Waterloo Estate (South) Concept SSDA, SSD-93222706

The following letter is provided in response to the traffic related comments received from City of Sydney Council (CoS), dated 2nd June 2026 and Transport for New South Wales (TfNSW), date 3rd June 2026.

Attachment 1. City of Sydney – McEvoy St and George St Proposal

Attachment 2. Revised Vehicle Access Location Assessments

ptcT_DWG_SK31.3

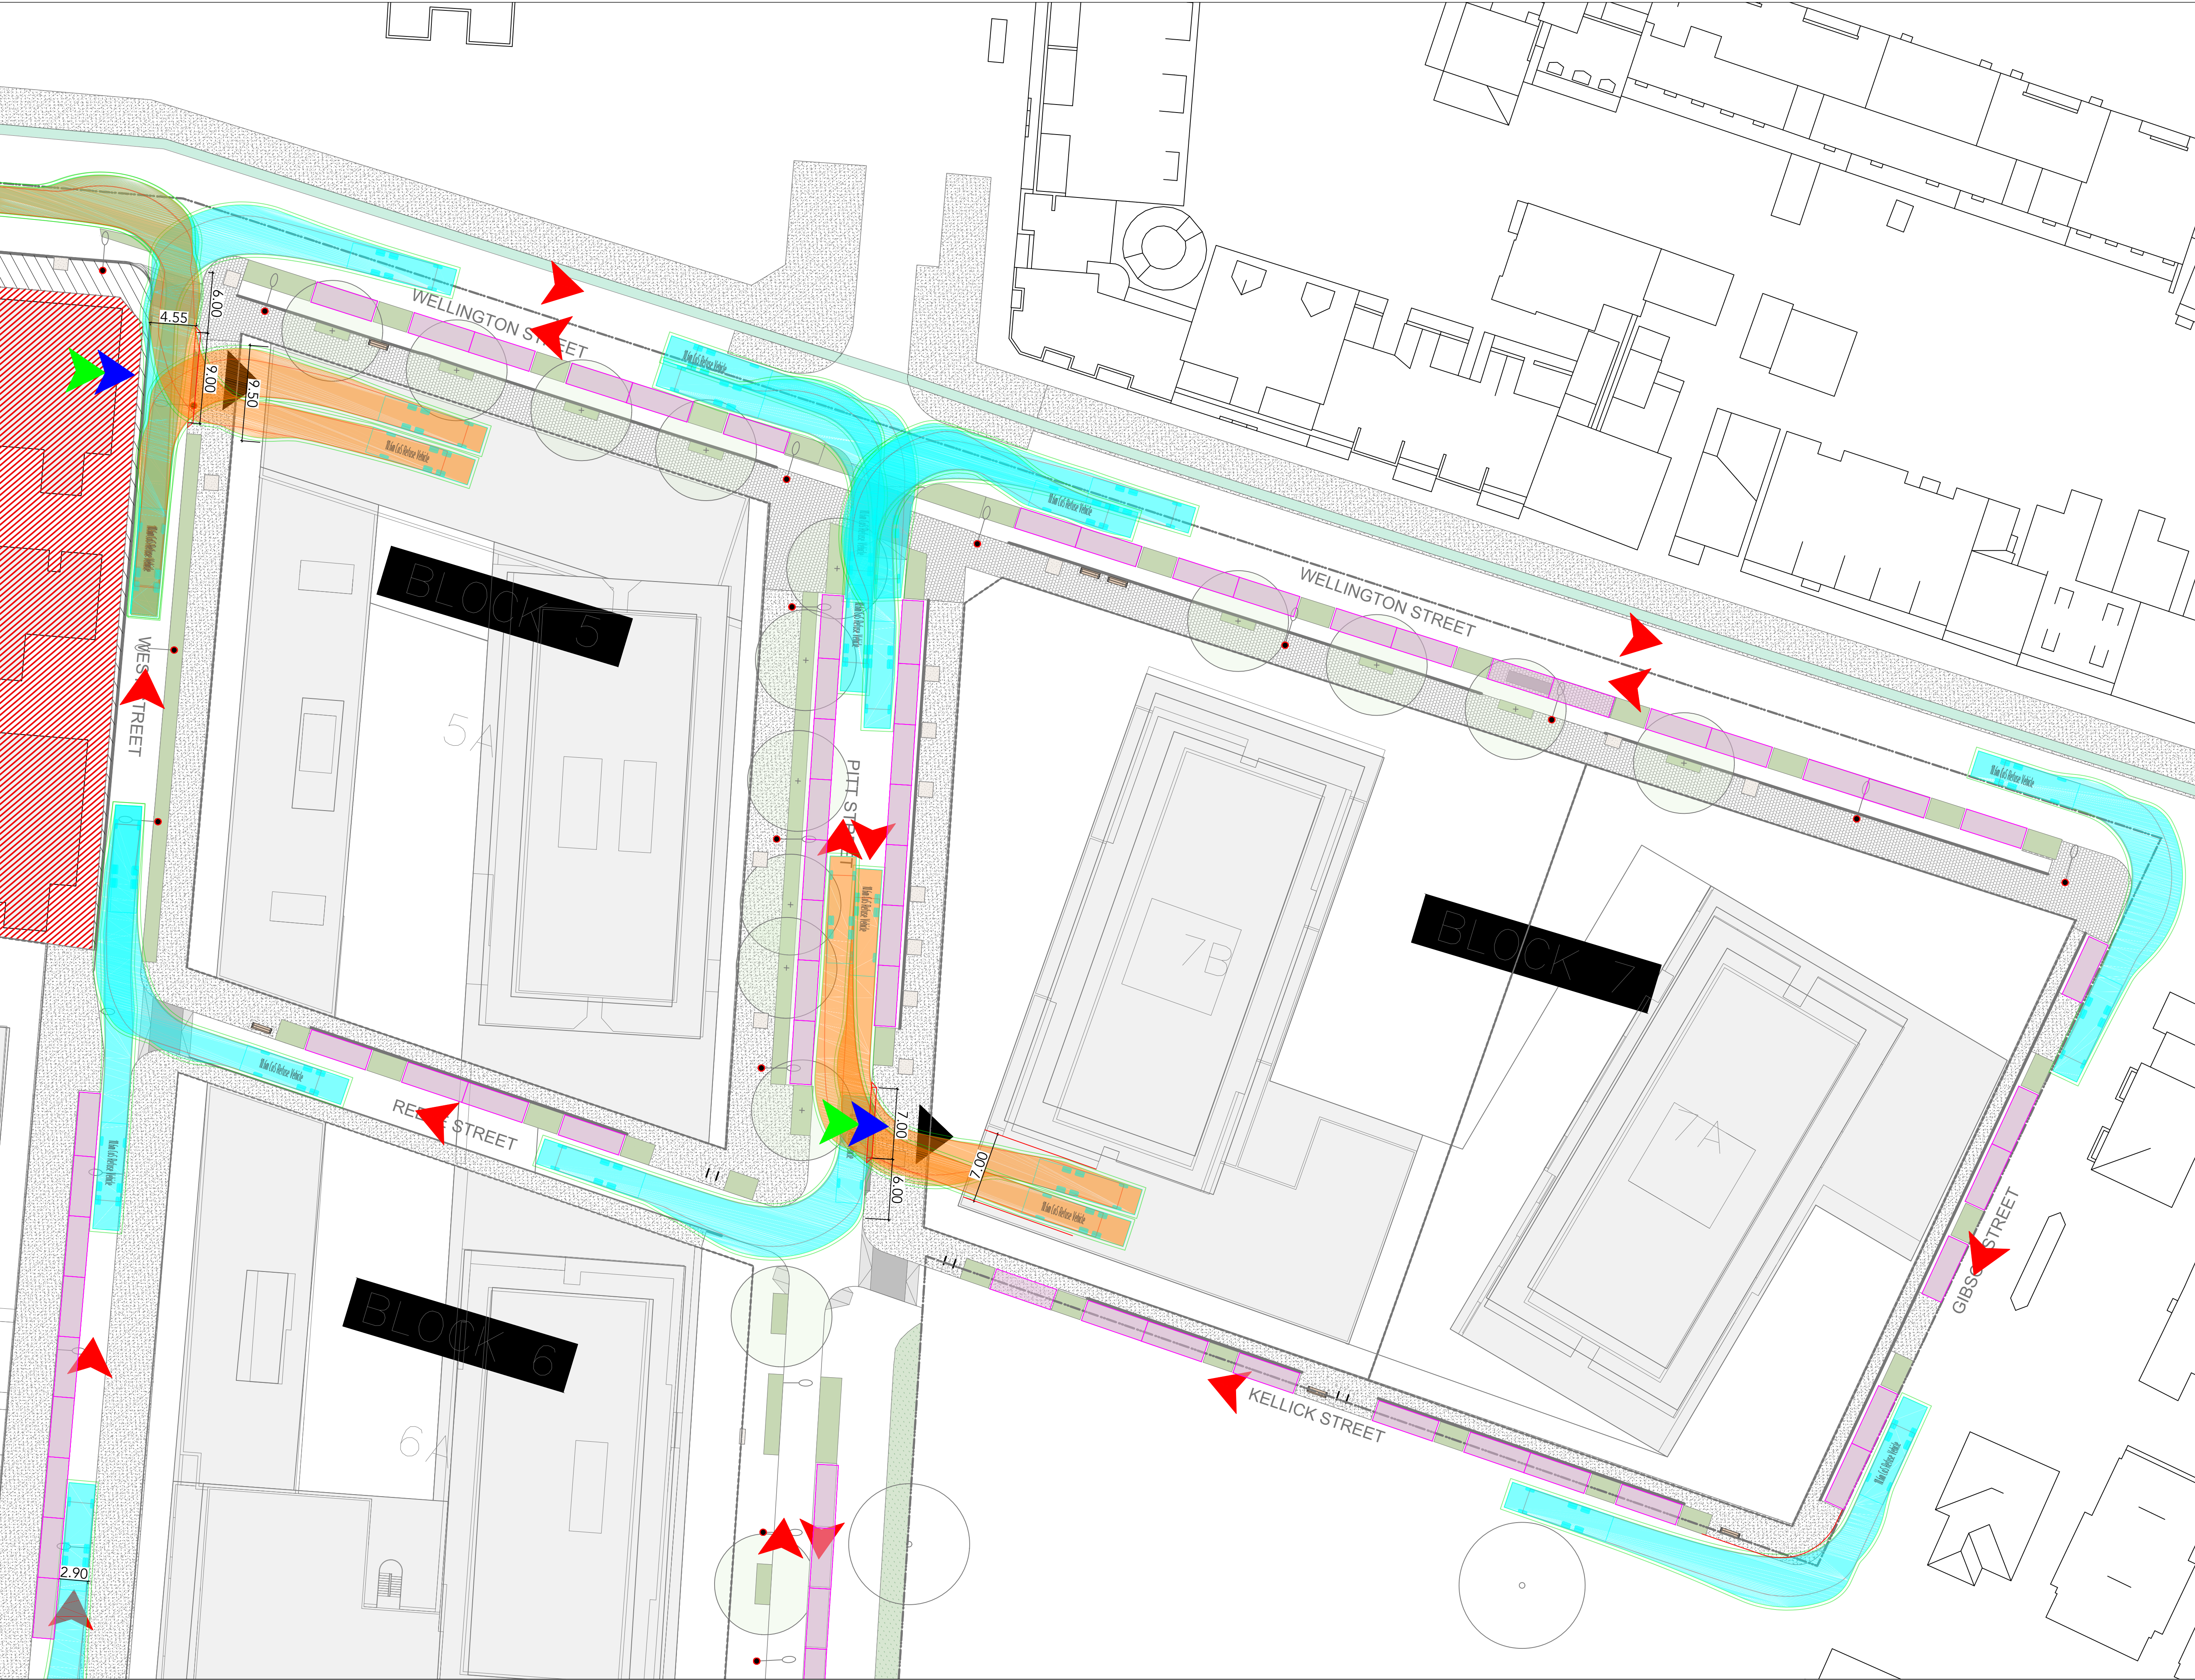
<table><tr> <th>Block</th><th>Recommendation</th><th>Notes</th></tr><tr> <td>Block 10</td><td>Narrow width of driveway to 6m</td><td>Proposed width is 8m. Swept paths allow for 899 to exit and enter simultaneously, which is excessive, as given slow speeds and low volumes (~50 vph) / hr based on their trip gen rate of 0.14 trips per dwelling.</td></tr></table>
